**GROUNDWATER MODEL WORKING  
GROUP MEETING NO. 11  
RED HILL BULK FUEL STORAGE FACILITY**

**JUNE 7, 2018**

# HALAWA DEEP MONITORING WELL DIAGRAM

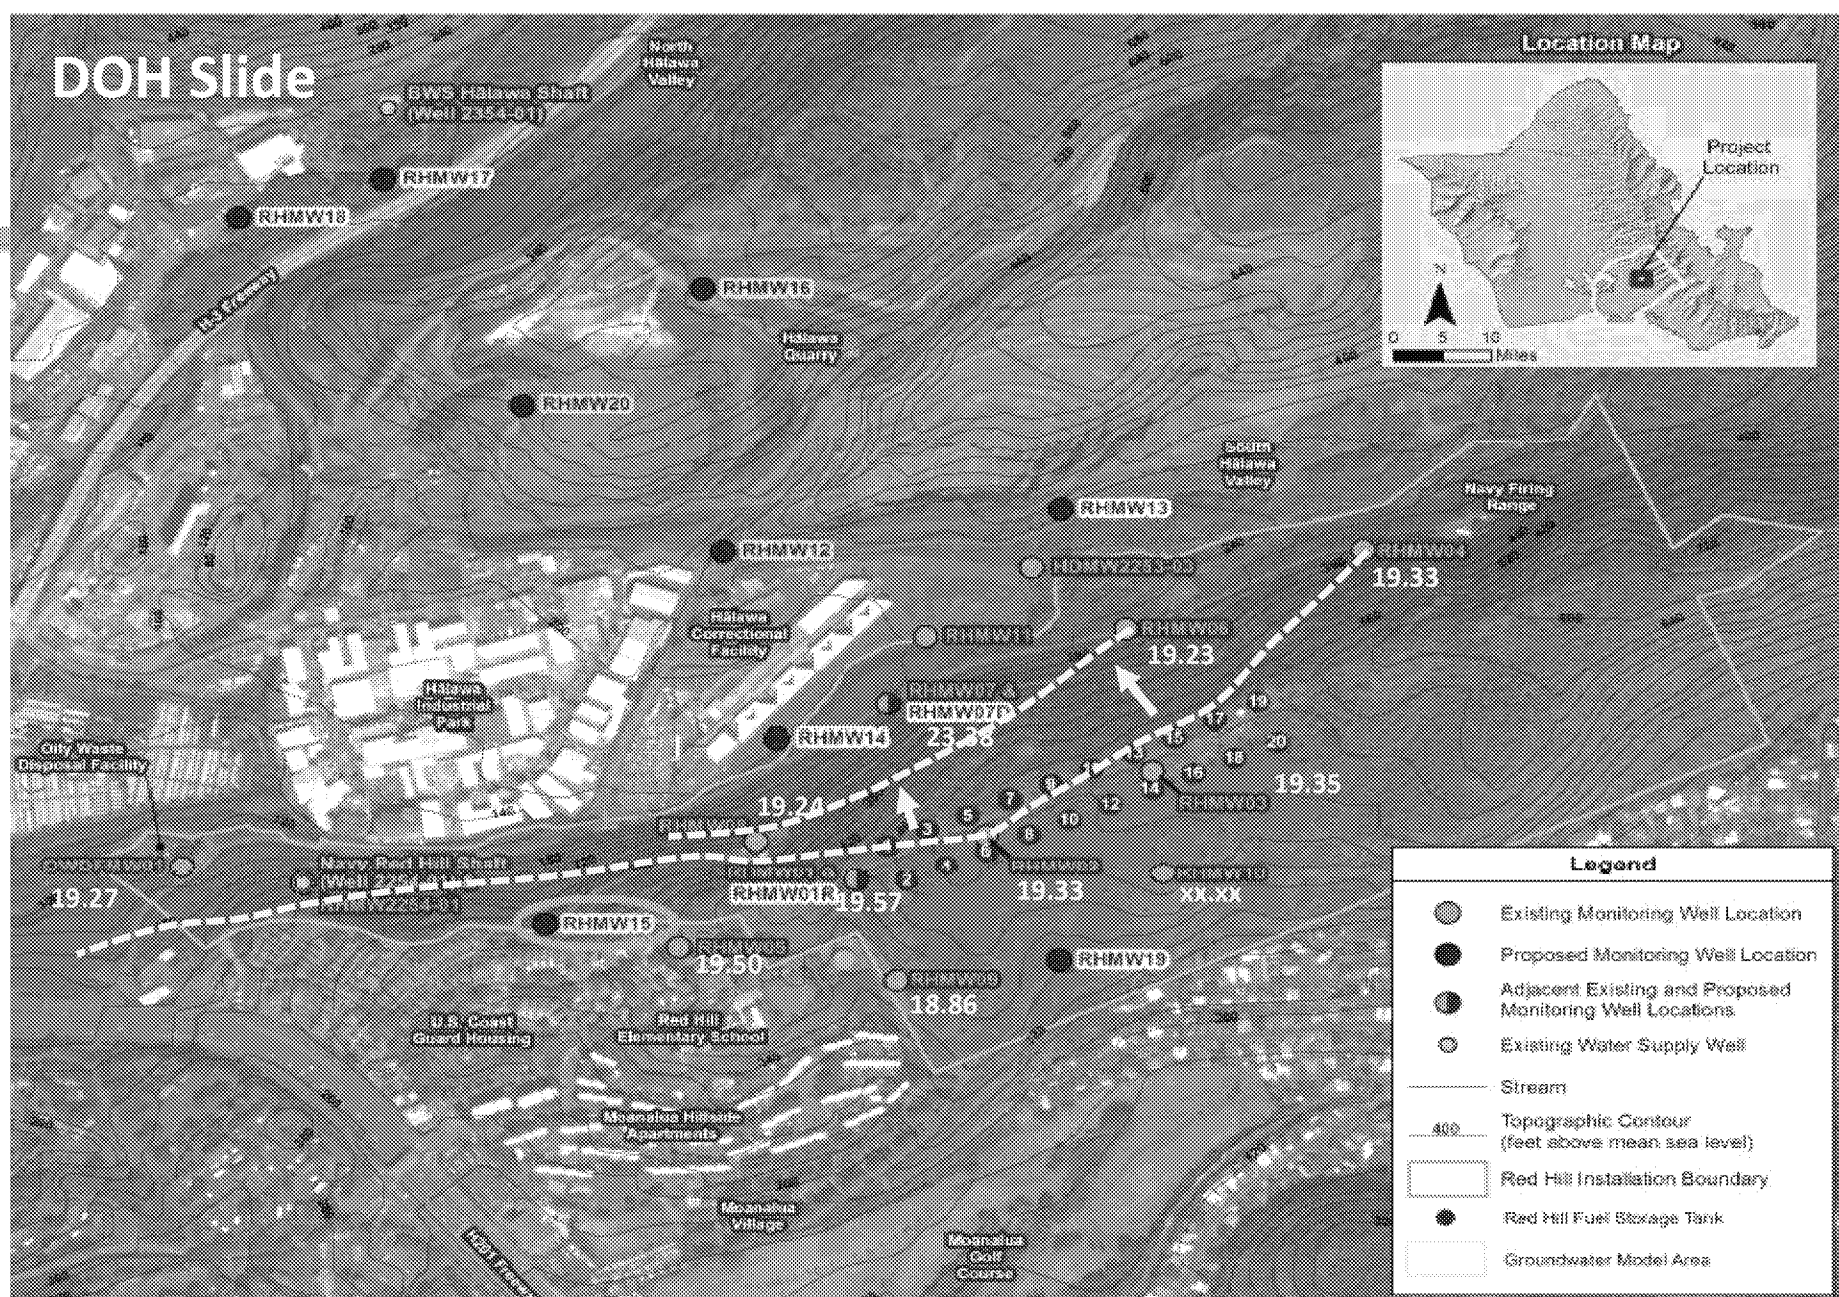
This map shows hand drawn groundwater contours of water levels measured during the April, 2017 groundwater sampling round. The groundwater elevation at RHMW07 was disregarded due to poor hydraulic connectivity. This quick first pass assessment implies a groundwater flow direction that does not in any way support the capture zone for the Red Hill Shaft modeled by AECOM and GSI.

# DOH Slide

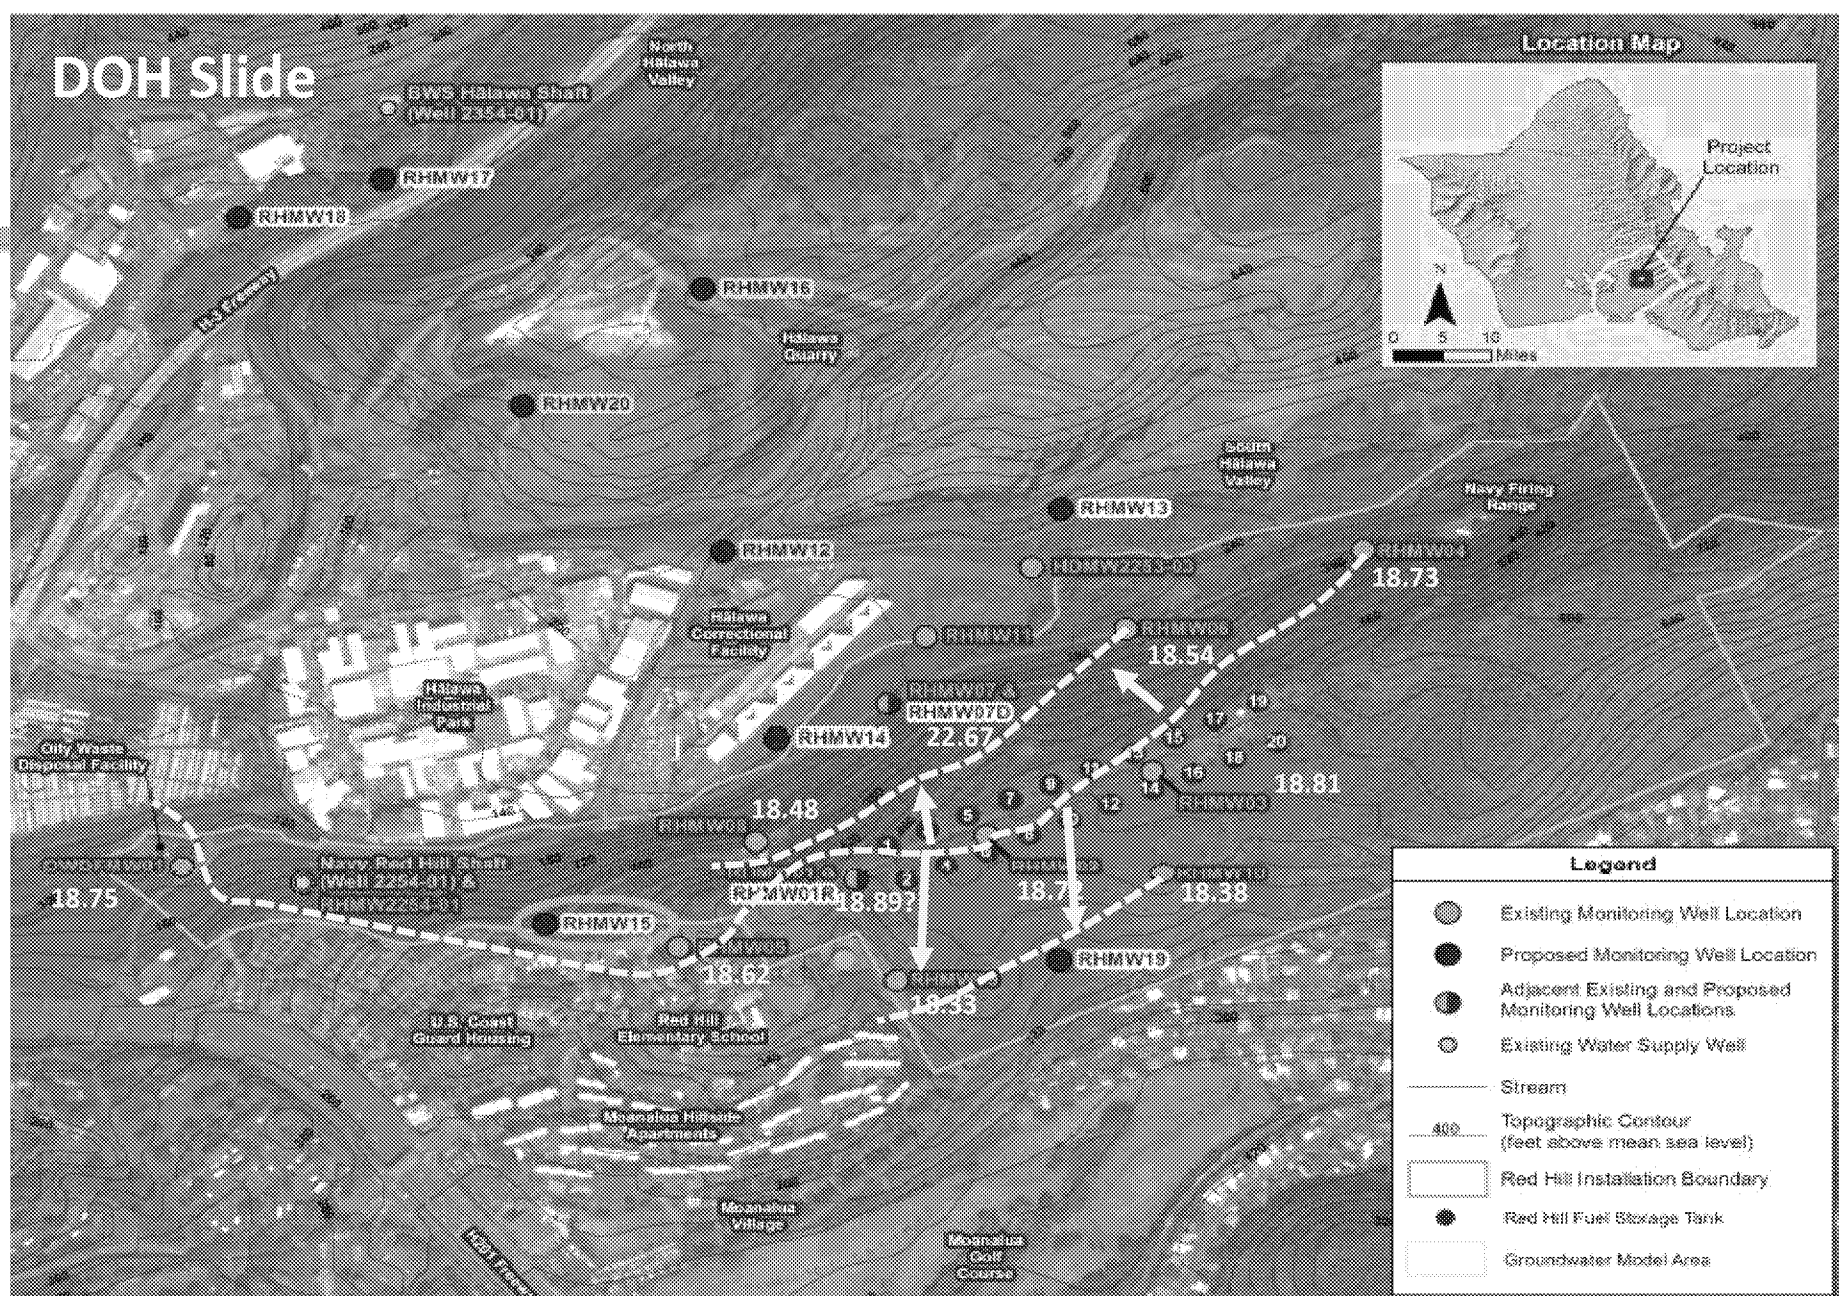
This map shows hand drawn groundwater contours of water levels measured during the July, 2017 groundwater sampling round. The results are very similar to those based on the April, 2017 sampling round. Again, the groundwater elevation at RHMW07 was disregarded due to poor hydraulic connectivity. Also, the recorded water level for RHMW01 was 19.89 ft msl. This likely an error and a value of 18.89 ft msl was used for contouring.

# 2/20/18 DOH LETTER REGARDING GROUNDWATER LEVELS

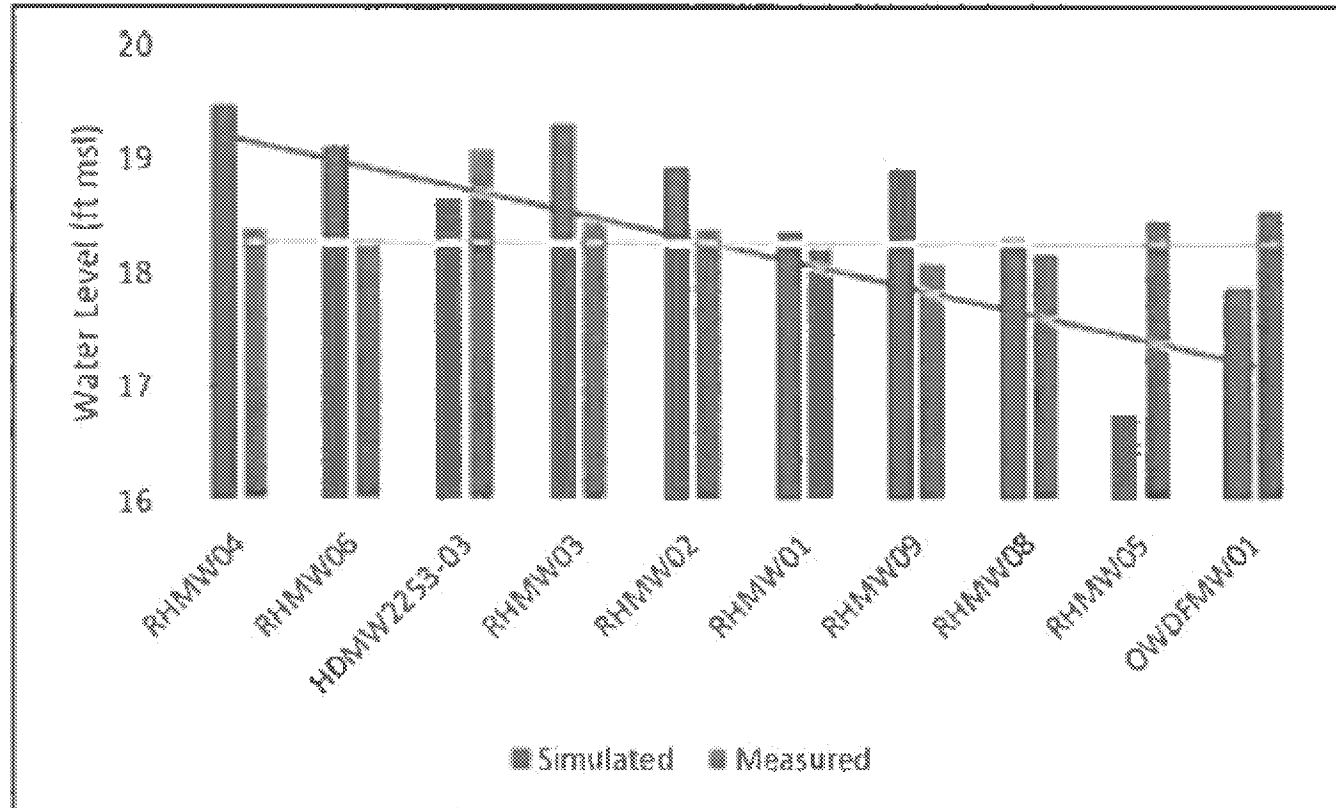
The bar graph below compares the modeled groundwater elevations (blue bars) to those measured in 2017 (orange bars). The data are arranged going from RHMW04, the most upslope well, to OWDFMW01, the most down slope well. A visually estimated trend line is drawn for each data set. The values for the modeled groundwater elevations were derived by applying the modeled residuals in Slide 30 to the average of water level measurements during the July and November rounds of groundwater sampling. For the modeled capture zone shown on Slide 57 to be valid there should reasonable agreement between the trend in the modeled and measured groundwater elevations. Clearly this is not the case...

# BWS COMMENTS CONTINUED

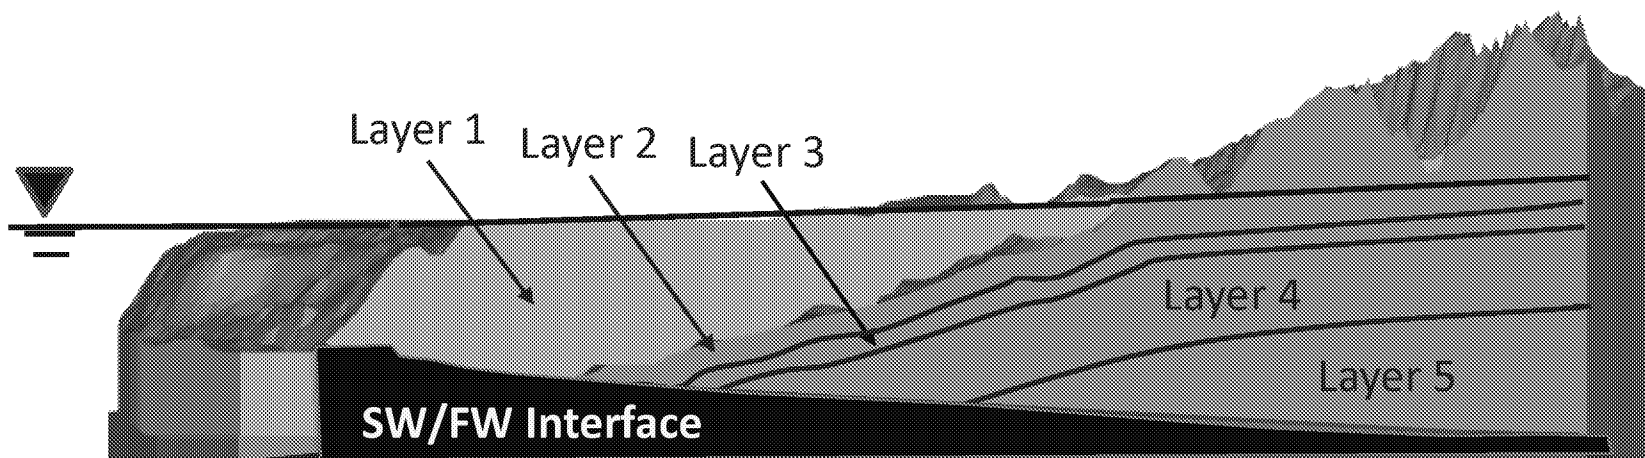
- ... discuss how the Navy will compare simulated and observed water levels, pumping rates and chemical concentrations
  - Flow model calibration metrics were provided in previous presentations and will be provided in the interim modeling report
  - Details of how the flow model calibrations performed were also provided in previous presentations and will be provided in the interim modeling report
  - December 2018 flow model calibration will be detailed in upcoming meetings and the flow model report
  - Transport model calibration to COPCs will be evaluated at the final model stage

# SLIDE 29 FROM APRIL 2018 GWFMWG MEETING: SENSITIVITY TO SAPROLITE PROPERTIES SAME AS BASALT – 2017 WATER LEVEL ELEVATIONS IN LAYER 2

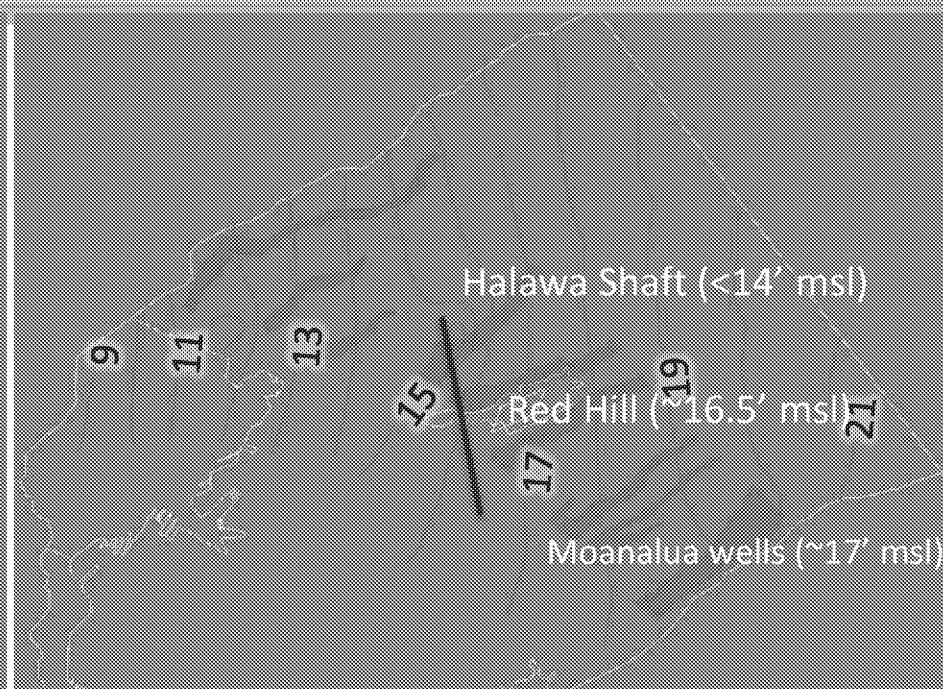
From BWS letter dated 4/30/18:

Examination of the Figures reveals that groundwater levels in **Moanalua Valley** (represented by the Moanalua, DH43, and TAMC MW02 wells) are higher than levels at Red Hill Ridge (represented by OWDFMW01 ), which are **in turn higher than groundwater levels in Halawa Valley** (represented by Halawa Shaft, Halawa TZ, and Ka'amilo wells).

***This observed general pattern is contradicted by the Navy's interim groundwater model's predicted base case*** groundwater levels for model layer 2 on Slide 29.

- No mounding within sapolite as in base case
- Water levels in basalt are lower than for base case by about 2 feet
